INFORMAL DRC

KNOX & AMERICAN

EROSION AND SEDIMENT
CONTROL PLAN - PHASE 1

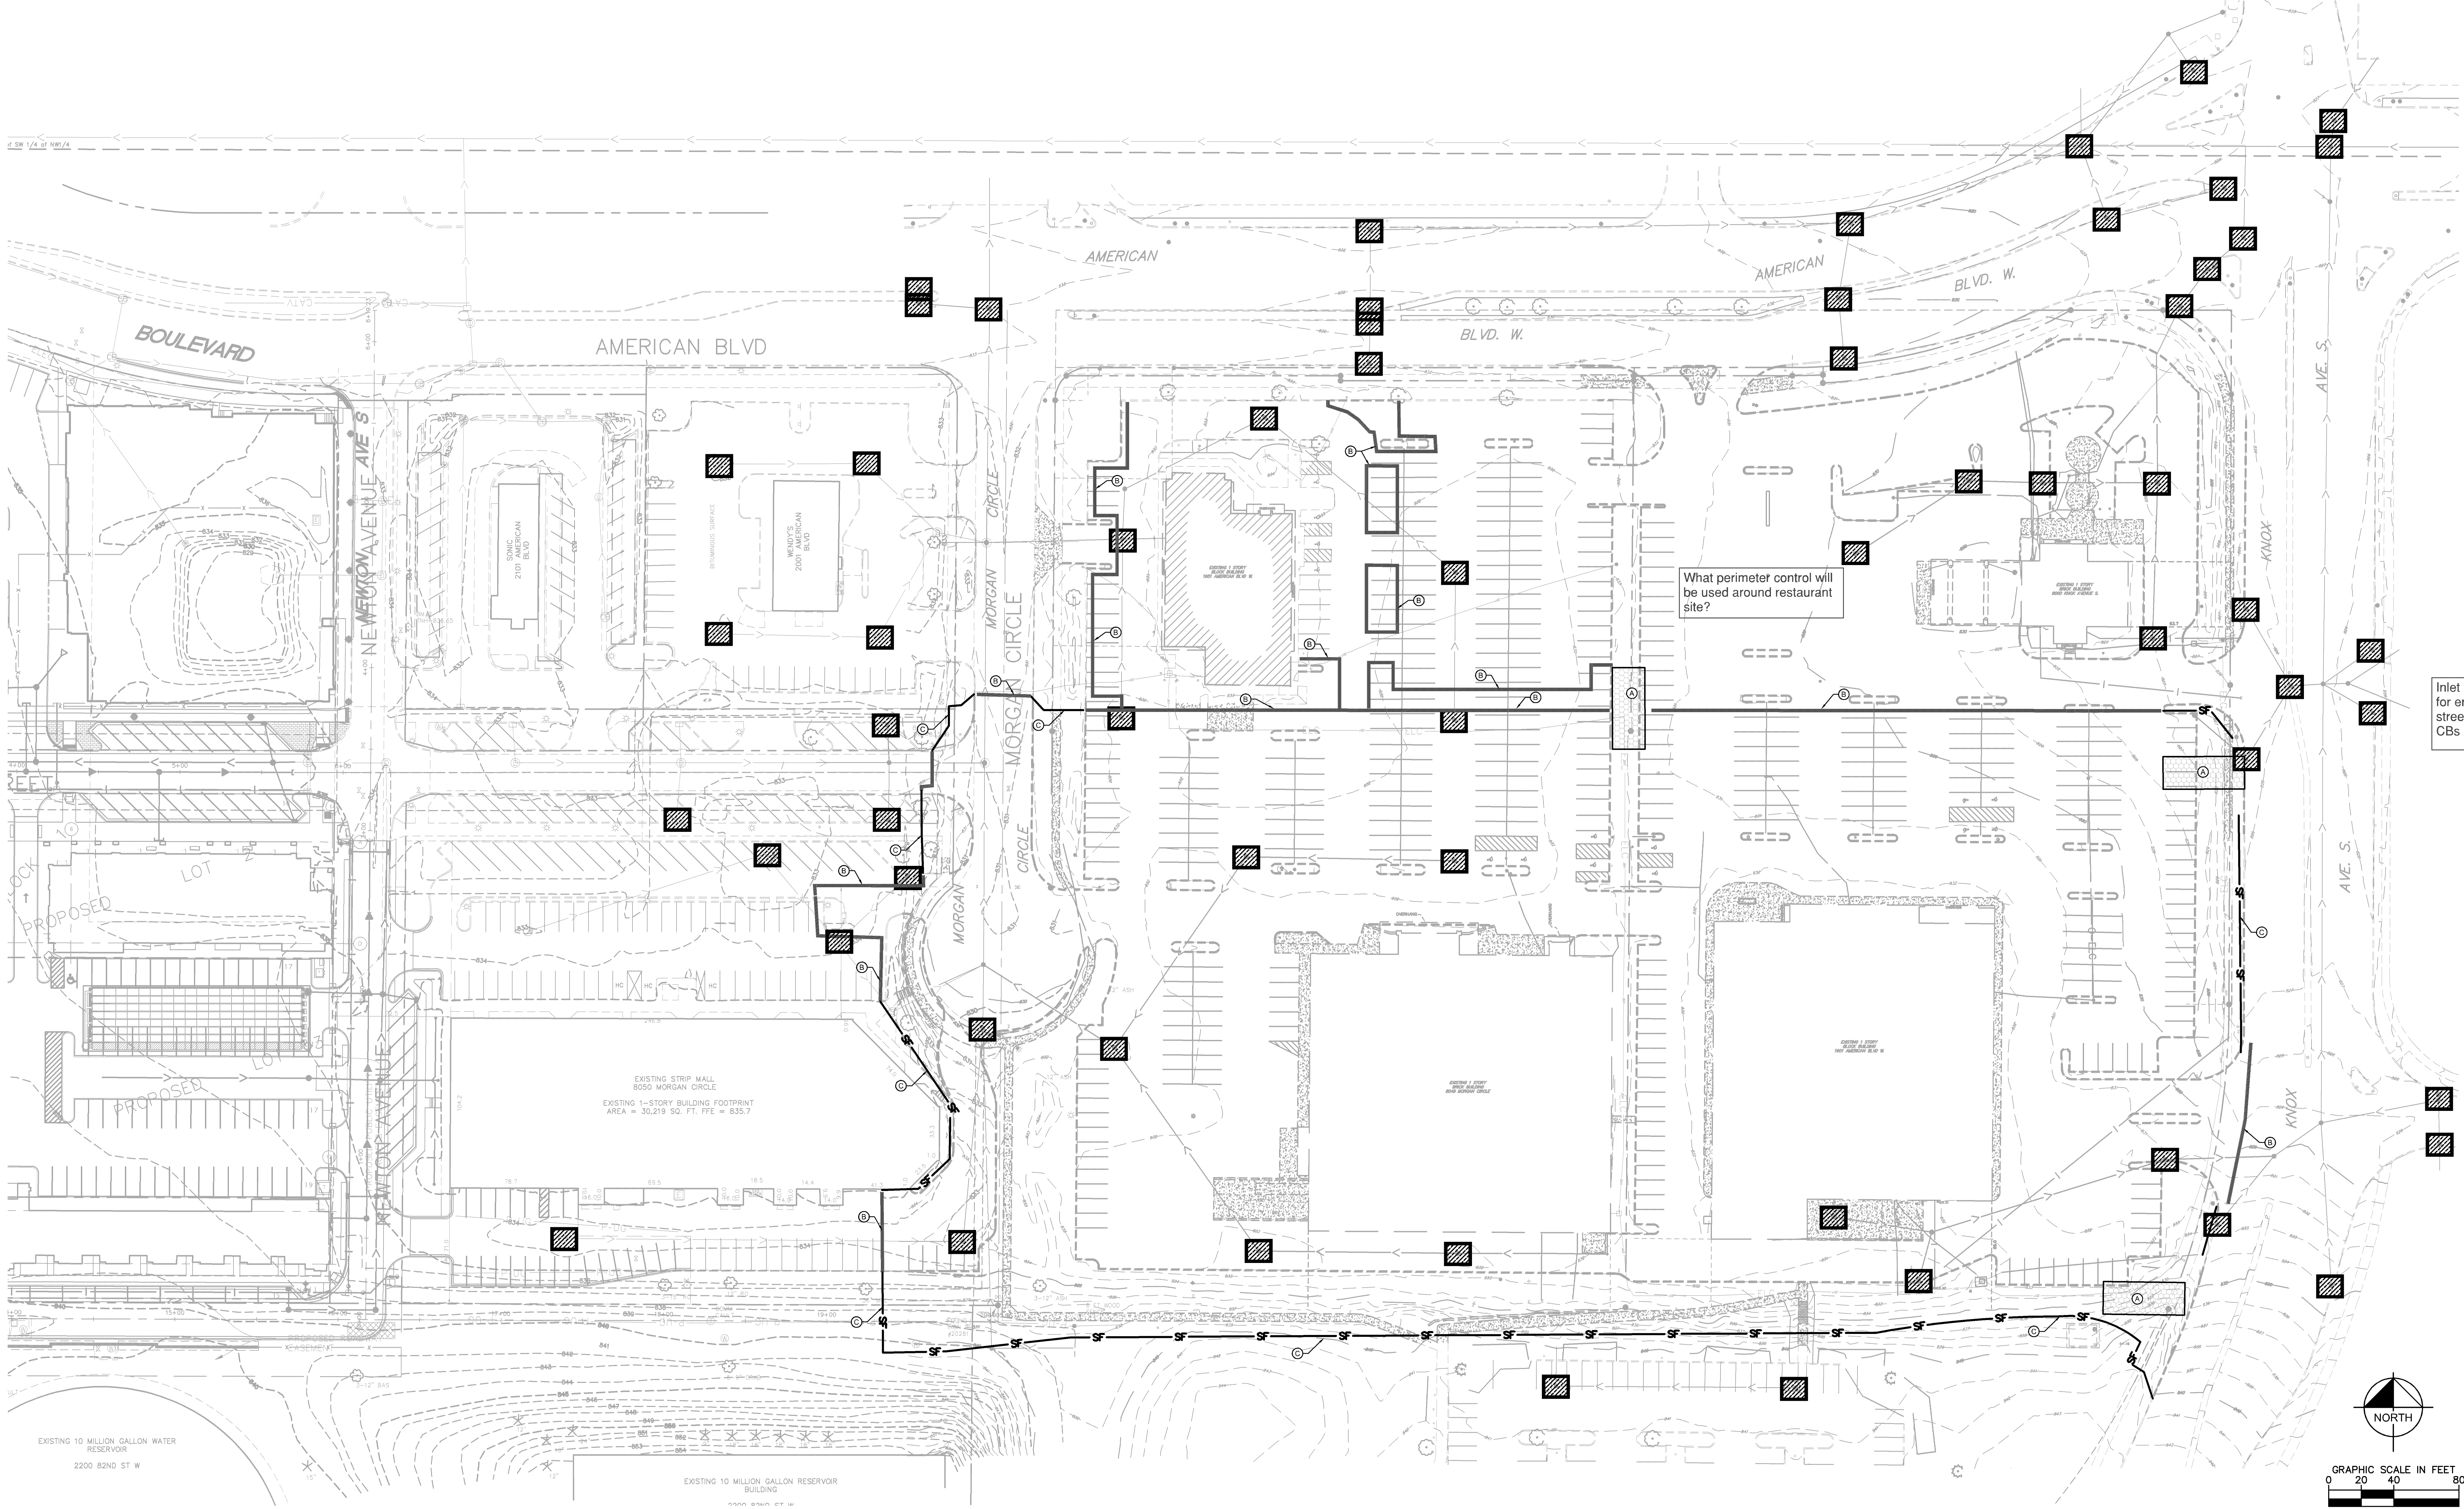
Inlet protection at low points must allow for emergency overflow to minimize street flooding. Use only at direct runoff OBs and MHS.

SITE PLAN - AMERICAN
BOULEVARD

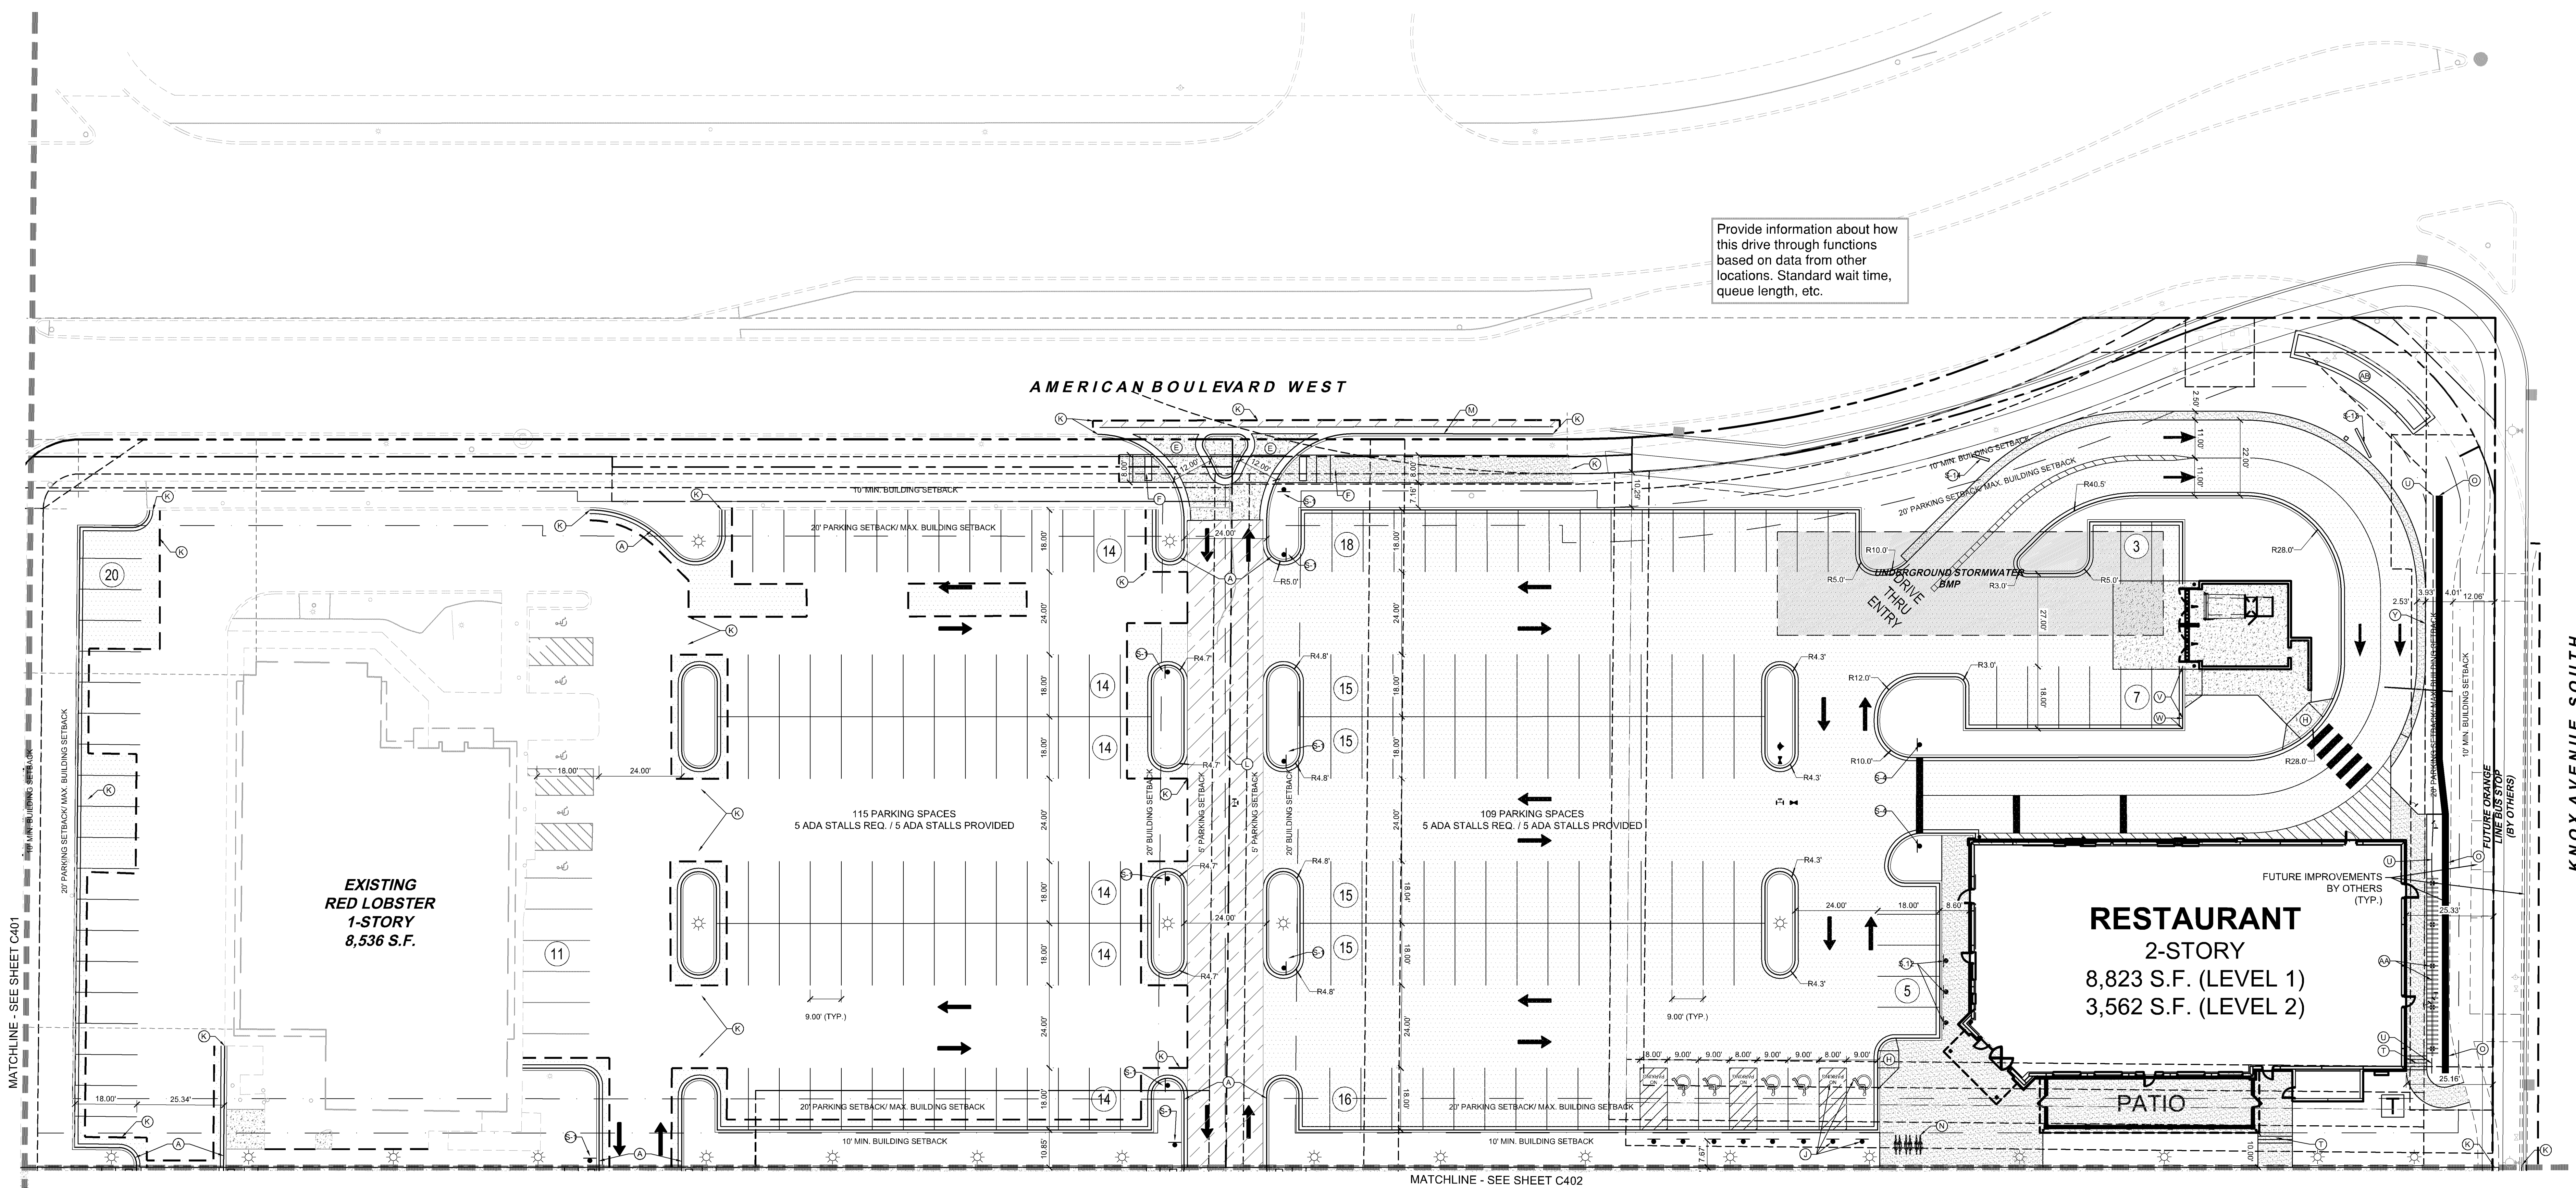
Provide information about how
this drive through functions
based on data from other
locations. Standard wait time,
queue length, etc.

GRADING PLAN - AMERICAN
BOULEVARD

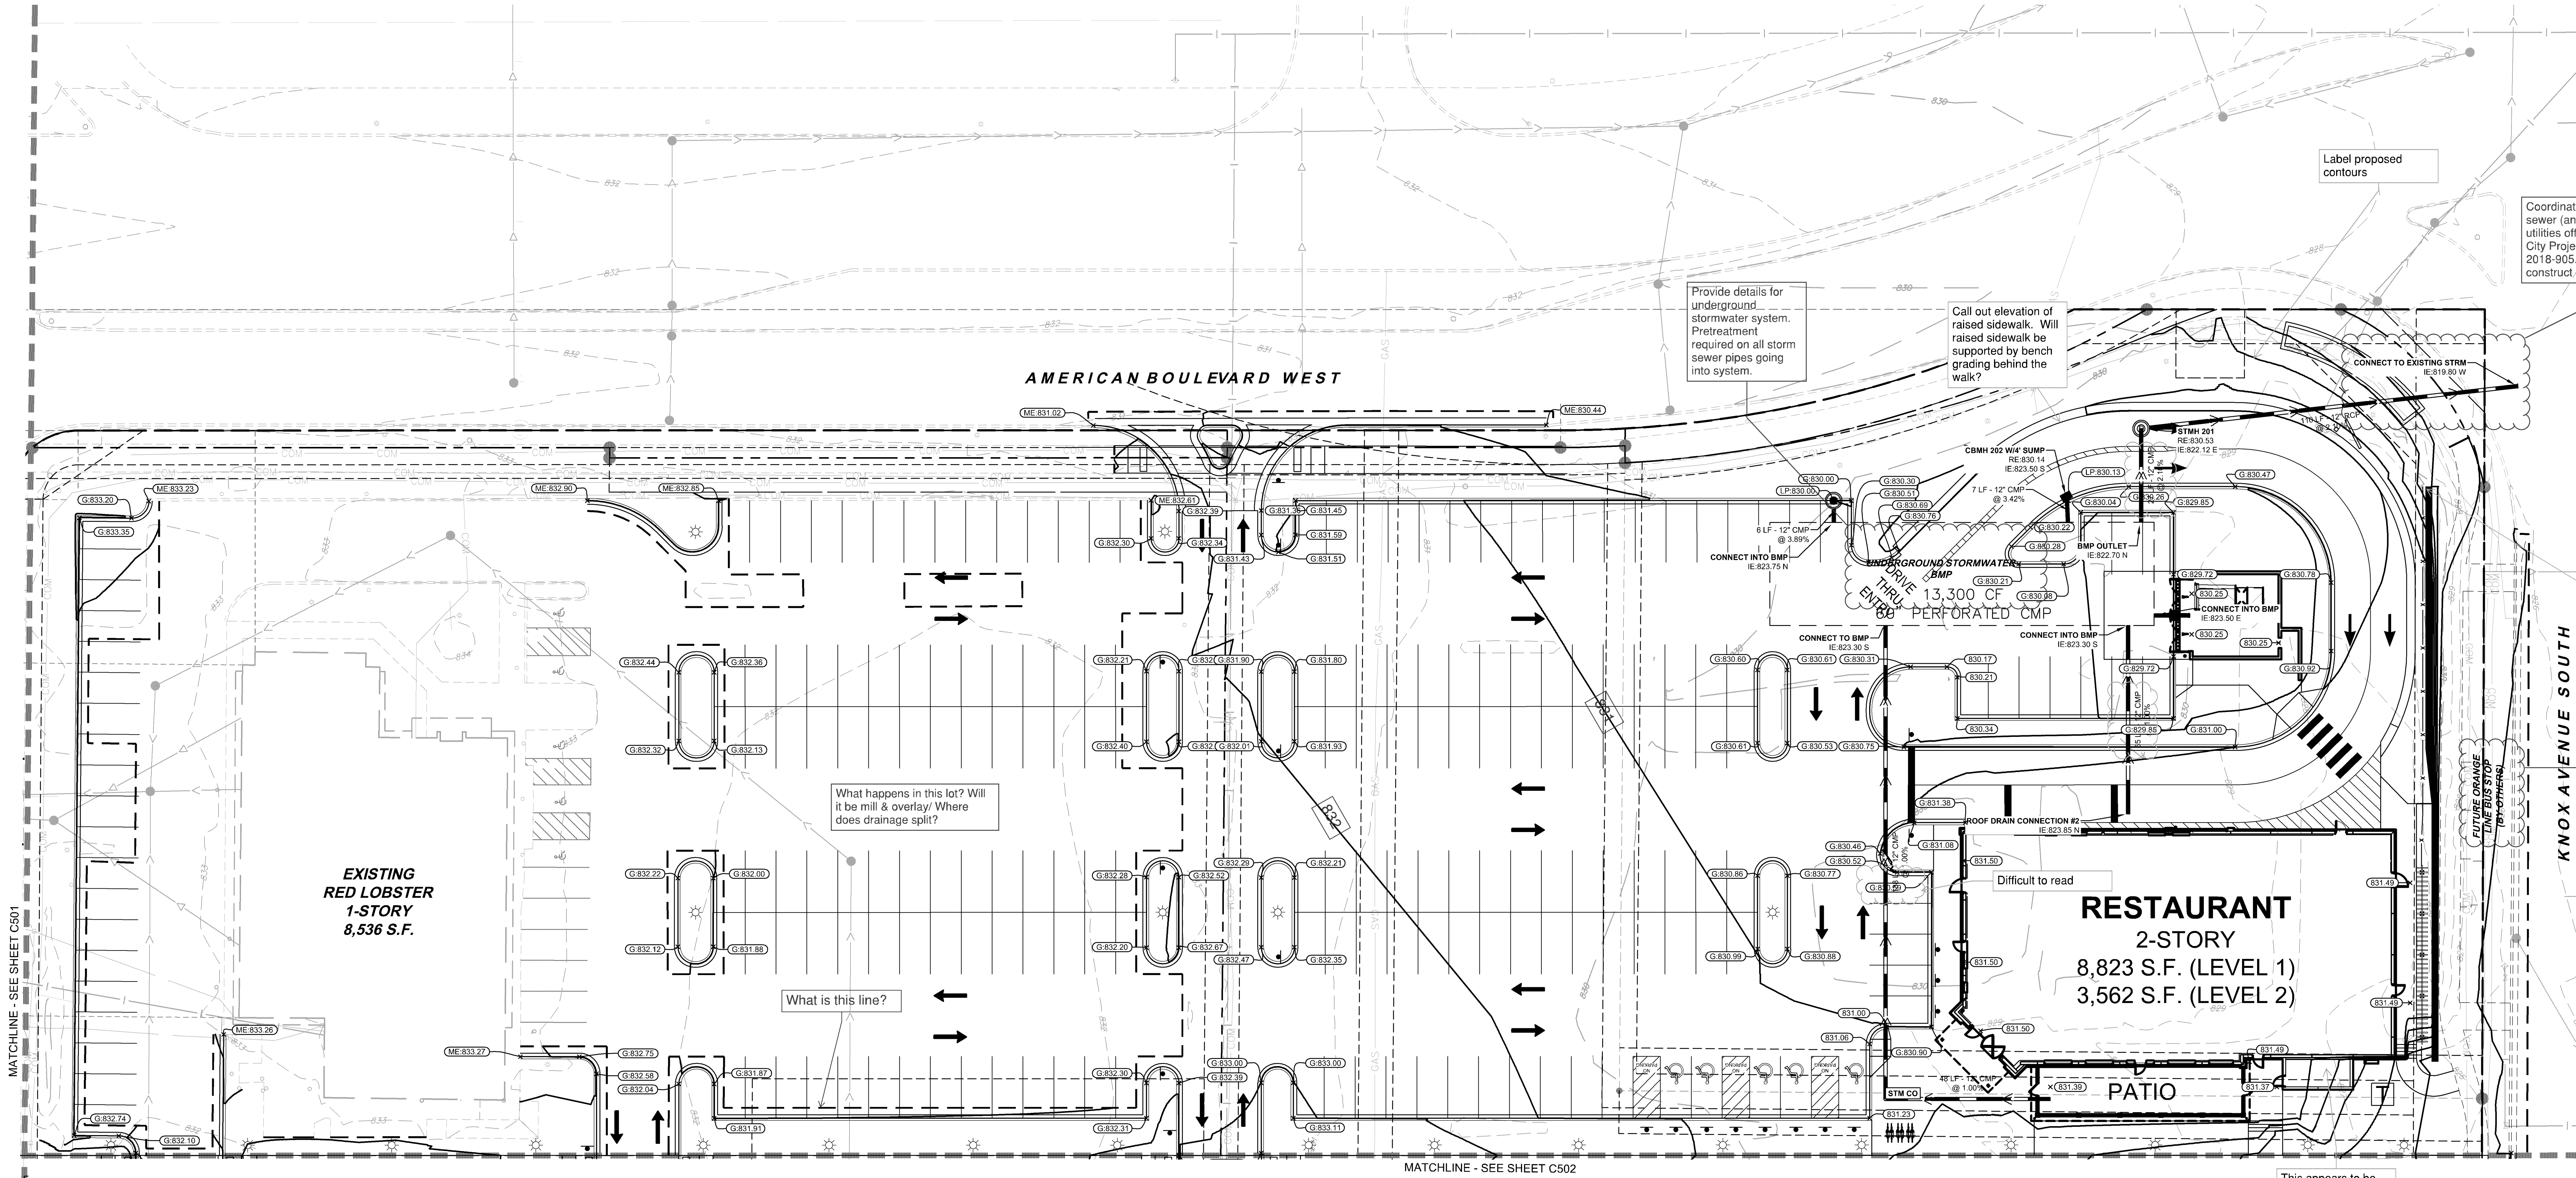
No ADA connection from
boulevard sidewalk shown
